**TOWN OF MOUNTAIN VILLAGE
REGULAR DESIGN REVIEW BOARD MEETING AGENDA
TO BE HELD IN PERSON
THURSDAY OCTOBER 7, 2021 10:00 AM
MOUNTAIN VILLAGE TOWN HALL
455 MOUNTAIN VILLAGE BLVD, MOUNTAIN VILLAGE, COLORADO
MOUNTAIN VILLAGE TOWN HALL**

TO: Mountain Village Design Review Board
FROM: Amy Ward, Planner
FOR: Design Review Board Public Hearing; October 7, 2021
DATE: September 27, 2021
RE: Staff Memo – Final Architecture Review (FAR) Lot 810A, 118 Arizona Drive

ROOF PLAN

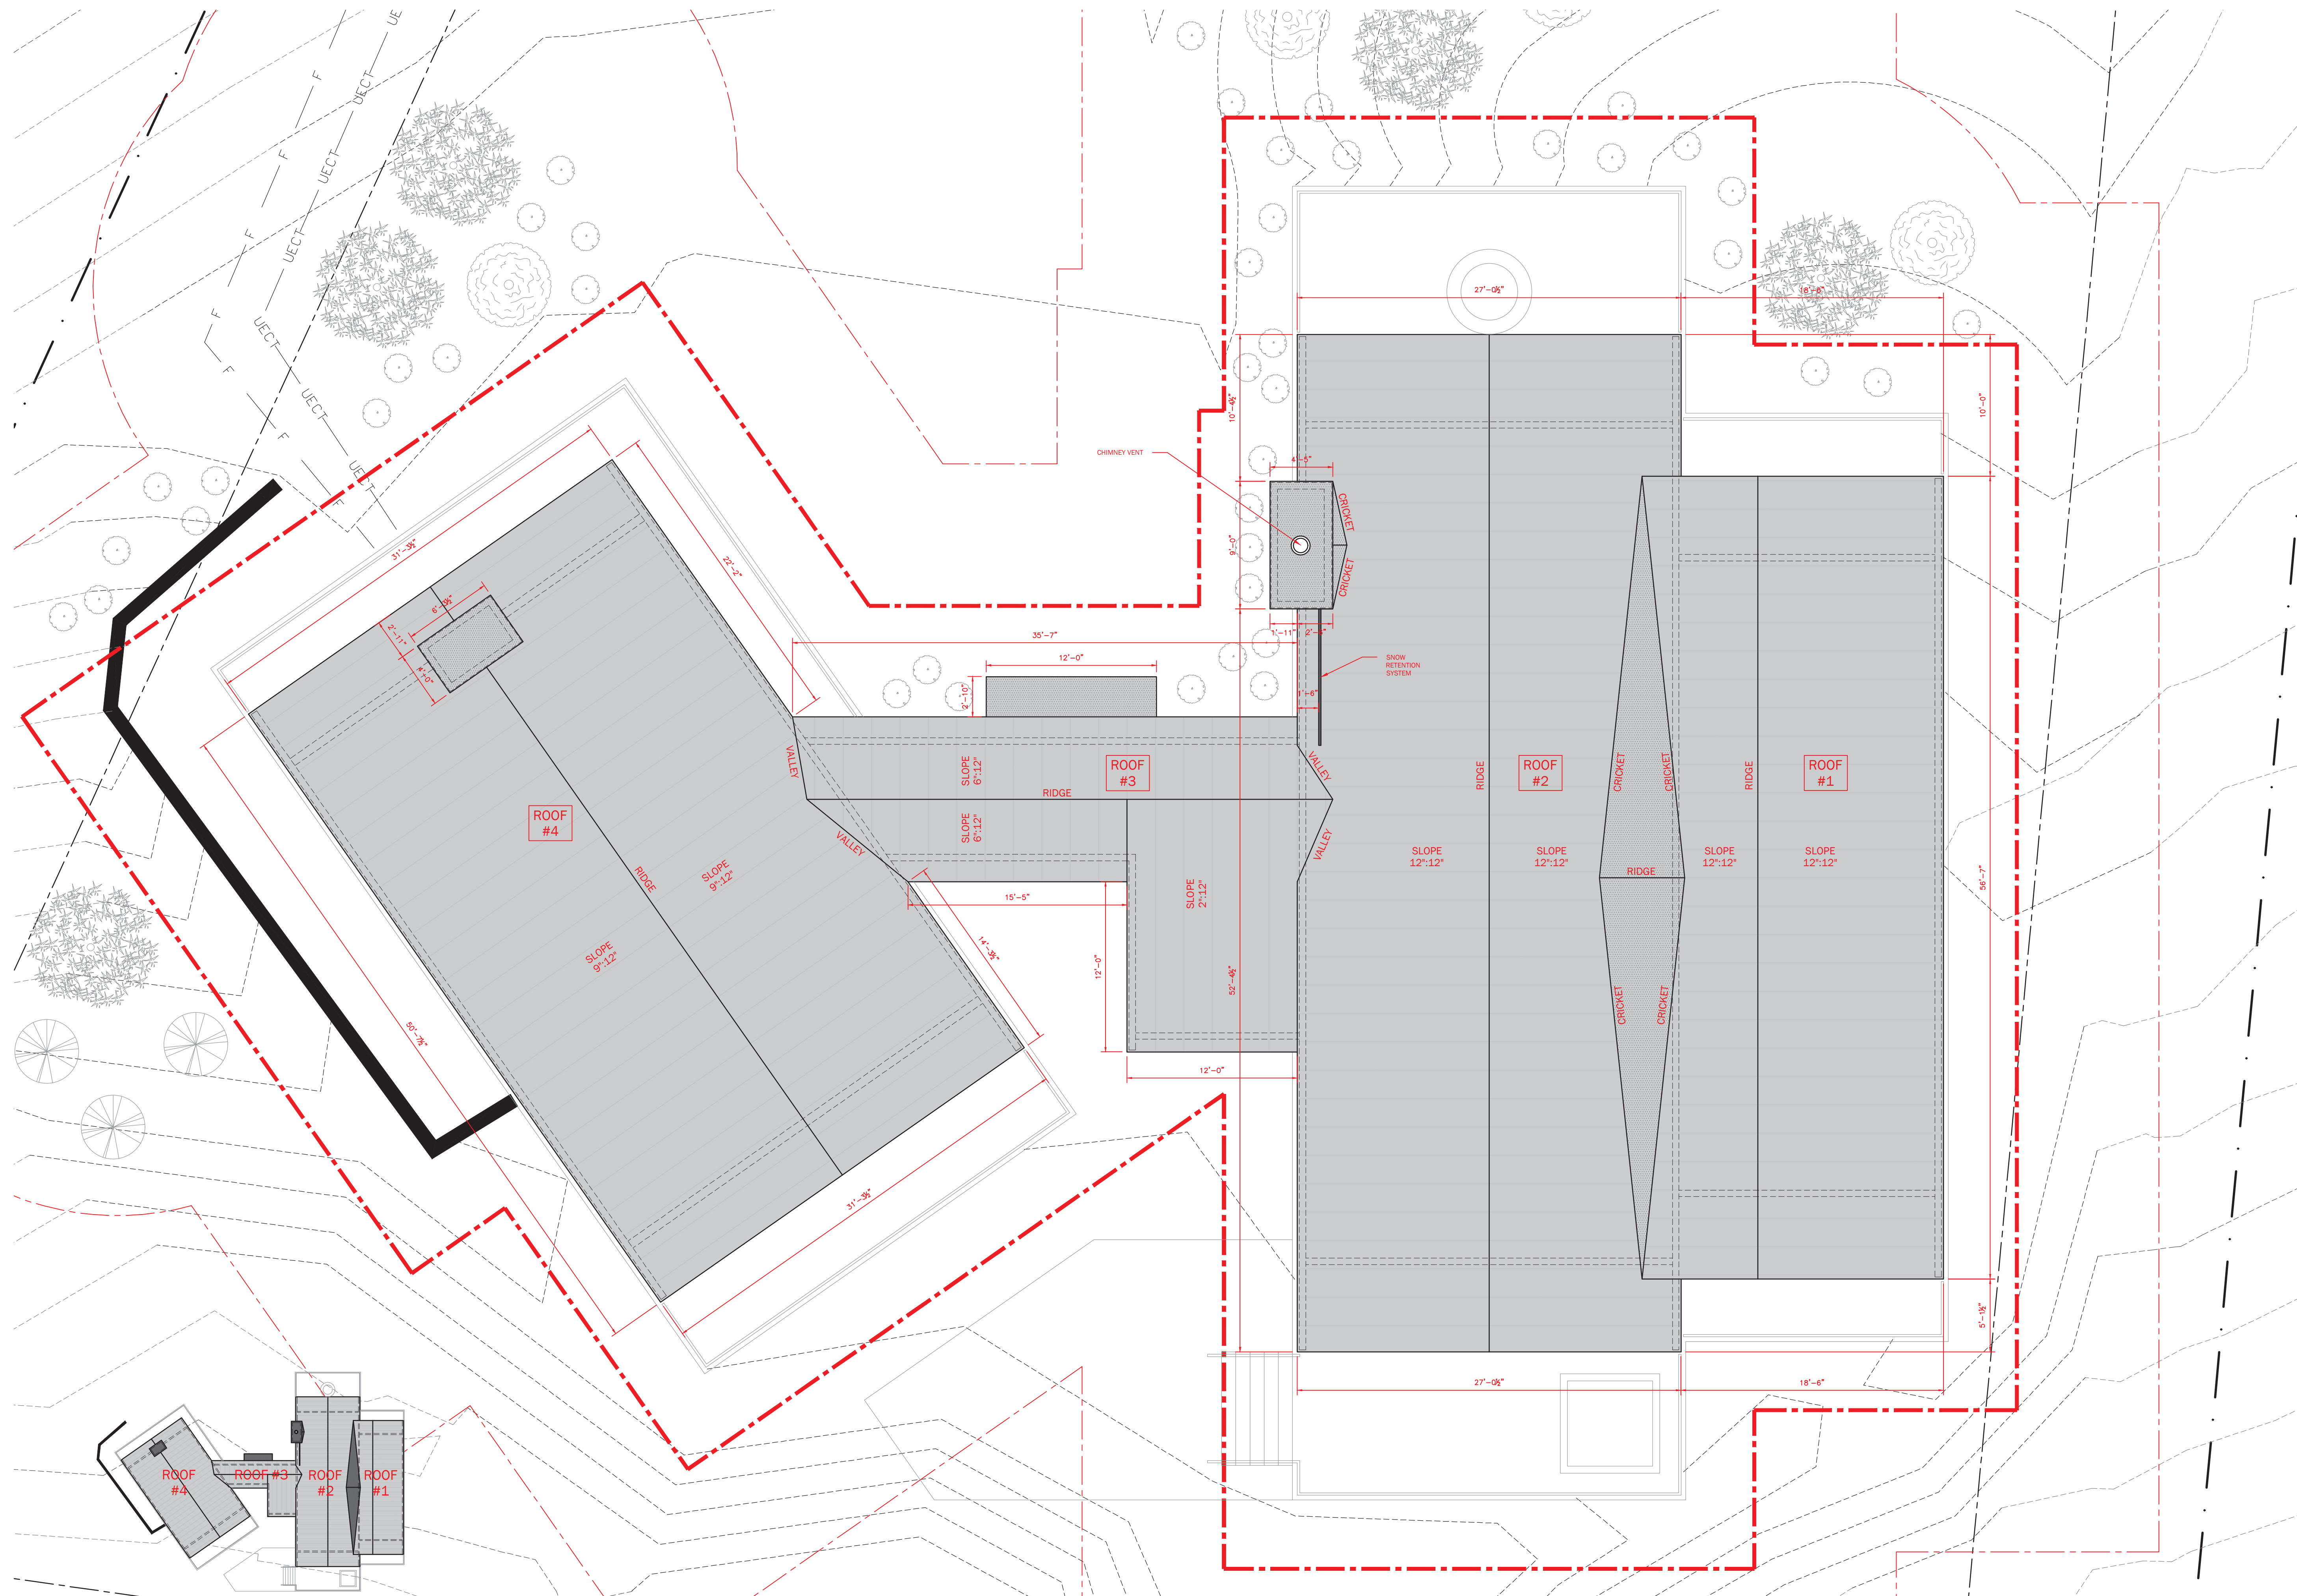
entry. Snow could still be an issue to the east of the front entry and the applicant has added snow guards to this area of concern. The patio surface to the west of the front entry is not very deep, staff is still concerned that snow falling could land on someone on the patio or on the driveway below and would like to see snow guards added here. The service area at the western most side of the house now has a roof surface protecting it. You can see this in elevation, but not on the roof plan. The applicant should submit a revised roof plan showing these changes prior to building permit.

- 3) Prior to building permit, the applicant shall provide a revised roof plan indicating snow fencing, and adding the roof over the back entry for staff review.

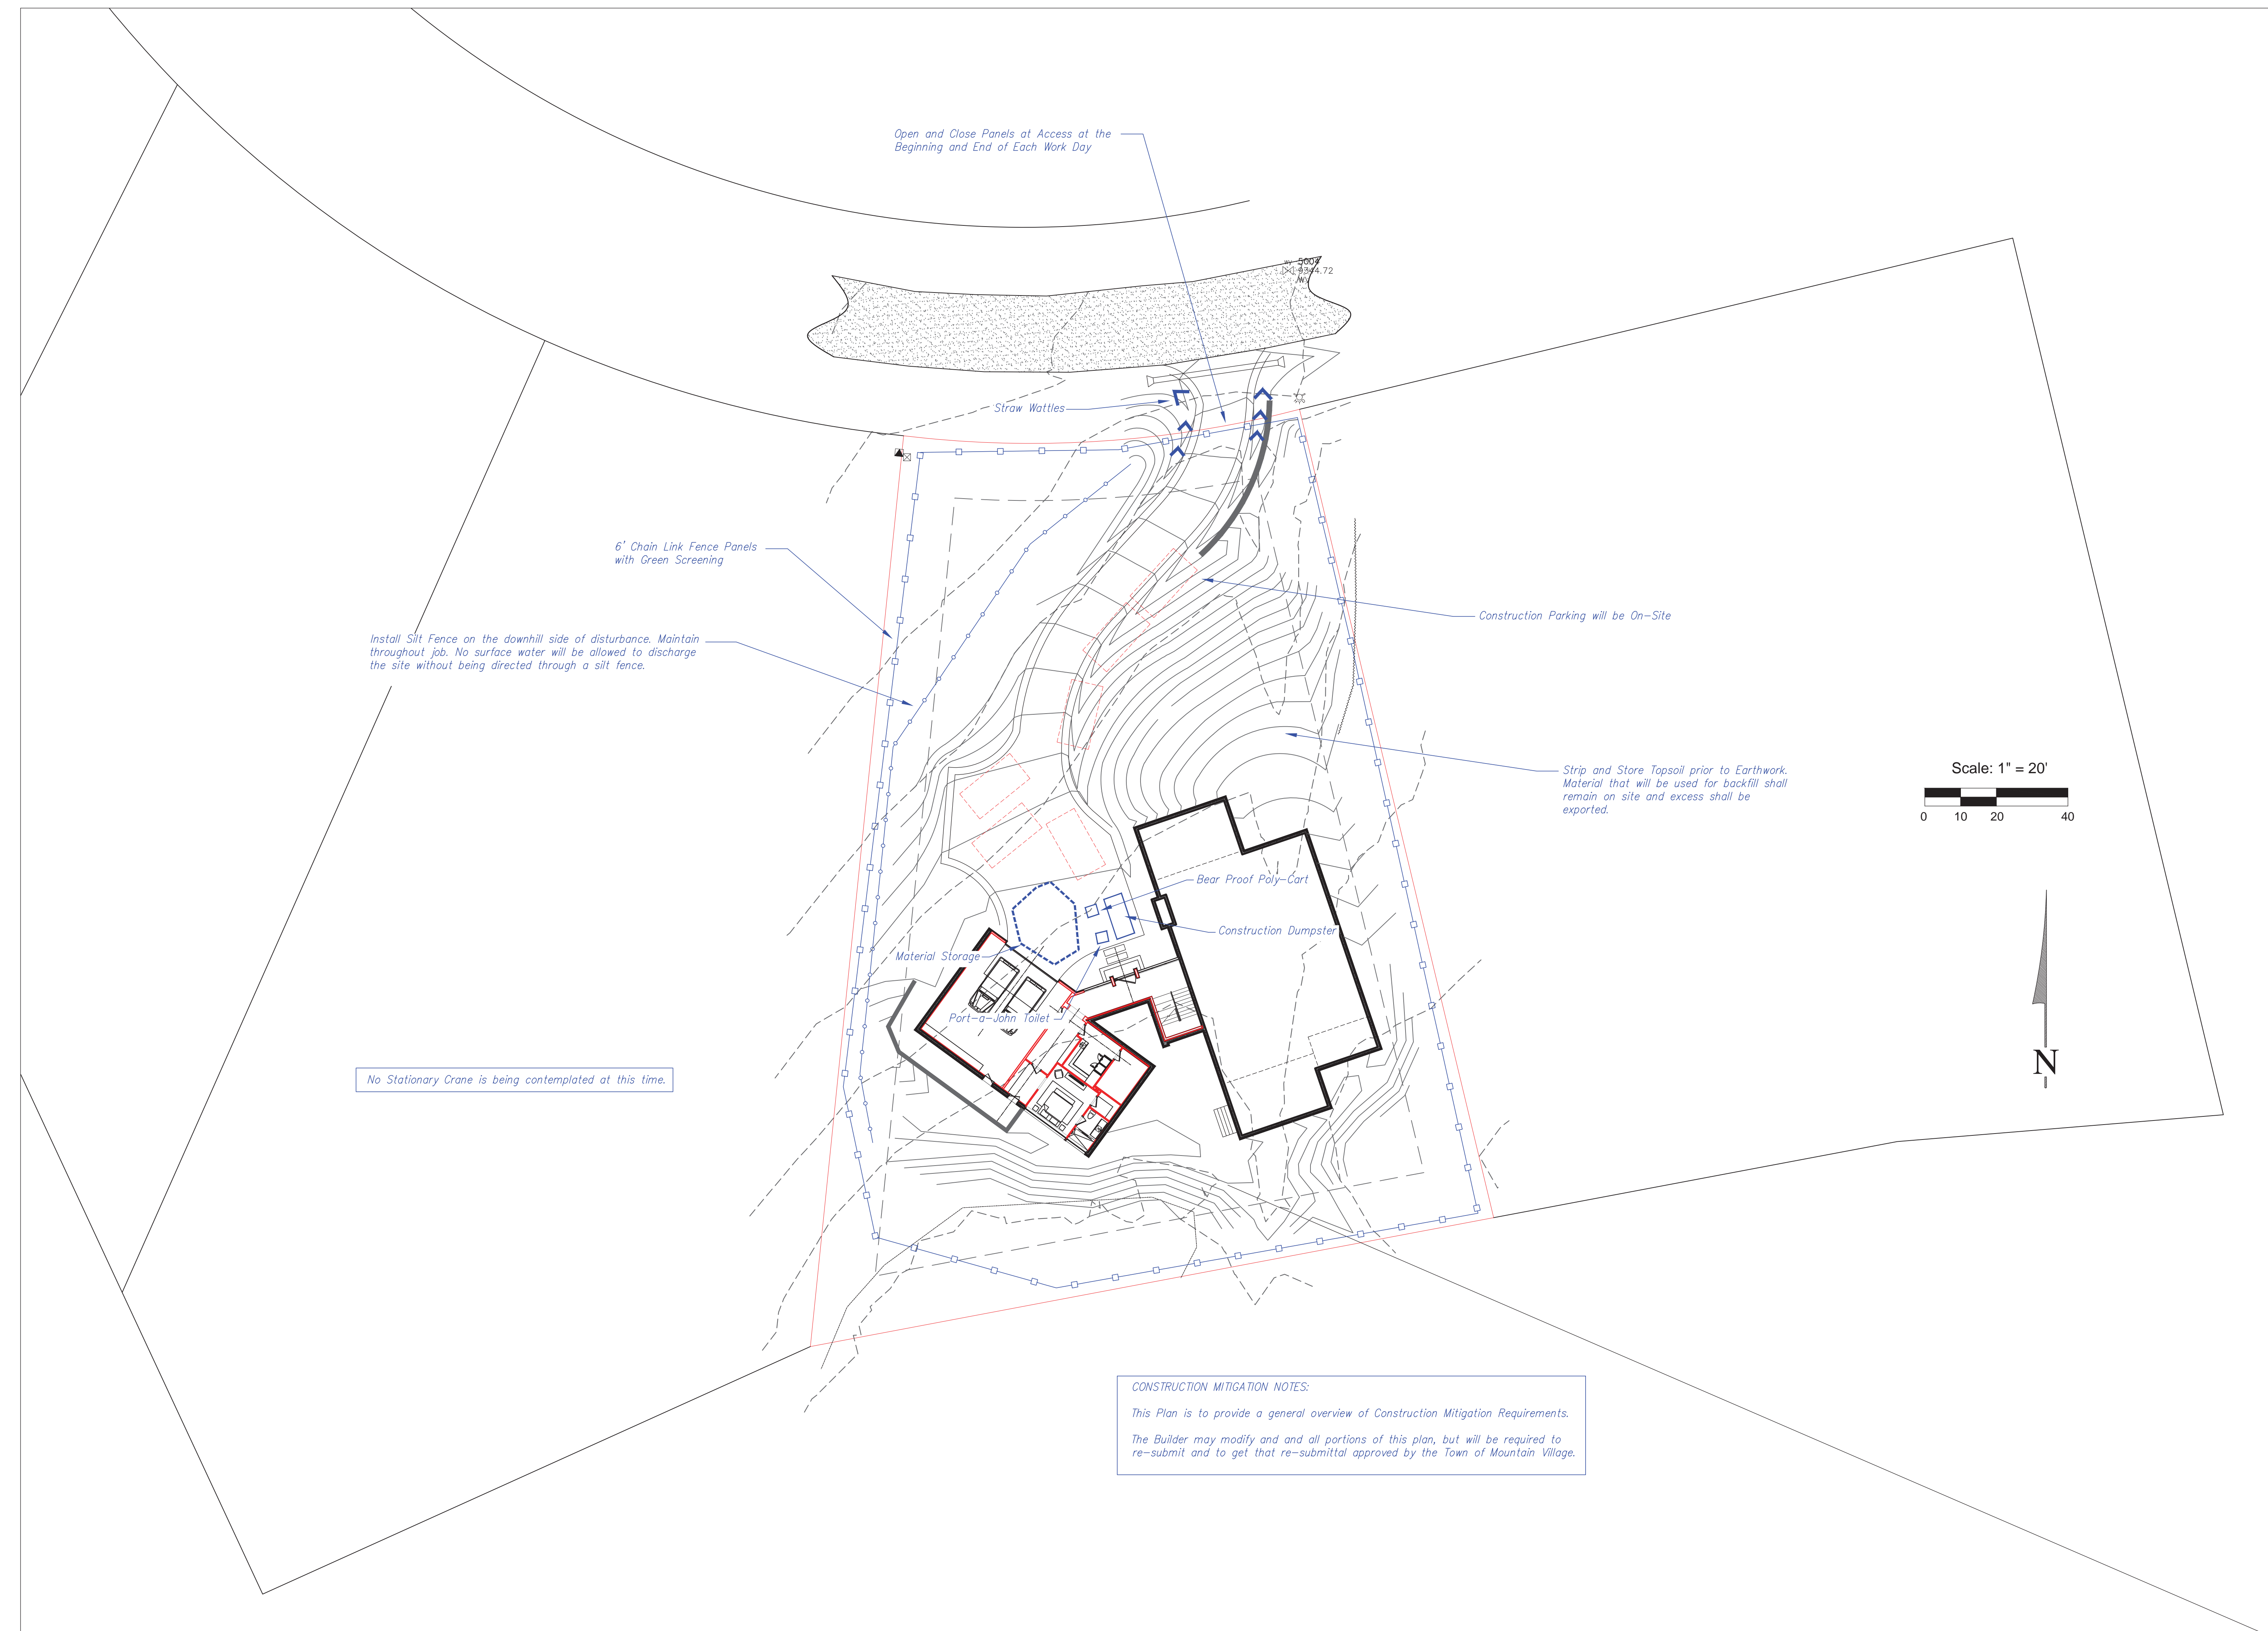
Staff: The applicant has not added an area of excavated dirt stockpiles and/or indicated the removal of such. The applicant should revise the construction mitigation plan to indicate how excavated materials are to be handled prior to building permit.

- 1) Prior to building permit, the applicant shall provide a lighting specification for the address monument for staff review.
- 2) Prior to building permit, the applicant shall revise the construction mitigation plan to calculate excavated material to be store or removed, and to indicate a staged parking scenario.
